Harrell Stream and Wetland Mitigation Site

Monitoring Year 4 (2023)

NCDMS Project No. 100005

Subject: RE: Draft Monitoring Year 4 (MY4) Report for  
the Harrell Stream and Wetland Site  
Little Tennessee River Basin – CU# 06010203– Jackson County DMS  
Project ID No. 100005  
Contract # 007006

MY4 CCPV  
 Harrell Mitigation Site  
 Jackson County, NC  
 December 2023

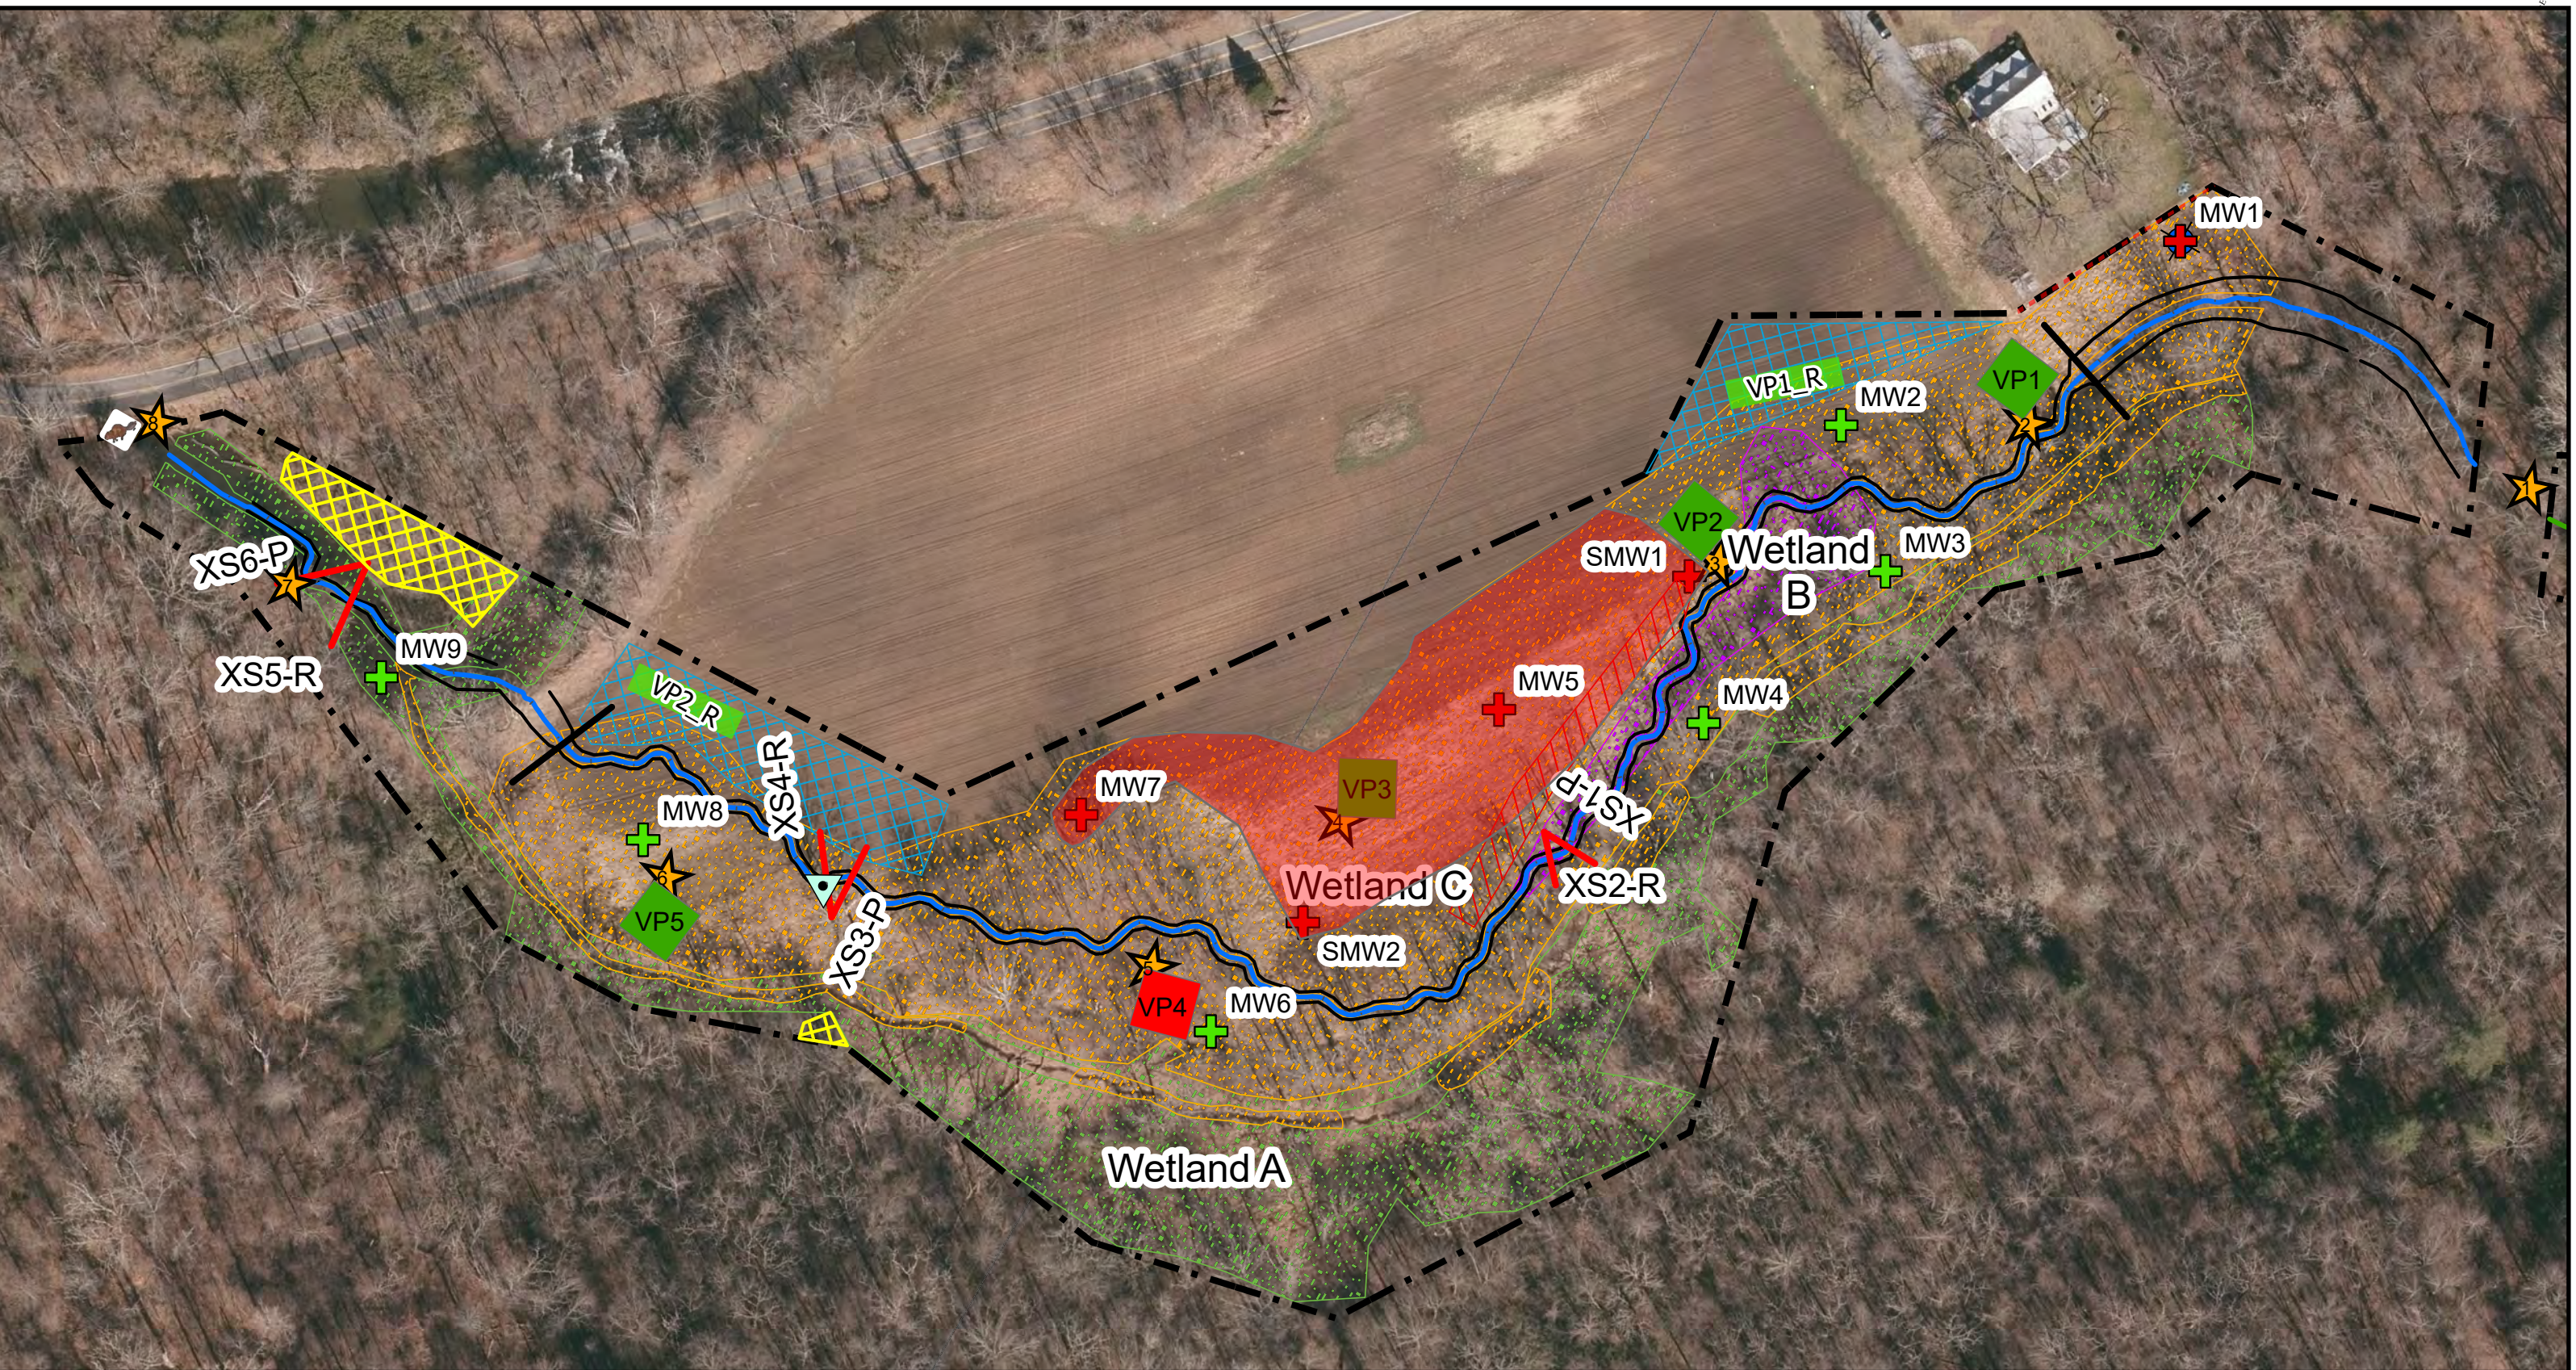
**Section 1.5.3 Hydrology & CCPV Map:** “*Based upon the past performance of groundwater wells 5 and 7 approximately 0.75 WMU’s remains “At Risk” within the project.*” Please review and confirm that 0.75 WMUs are considered “at risk” based on the monitoring year 4 (2023) data collected. Please show the “at risk” wetland credit area on the MY4 (2023) CCPV map. **Updated.**
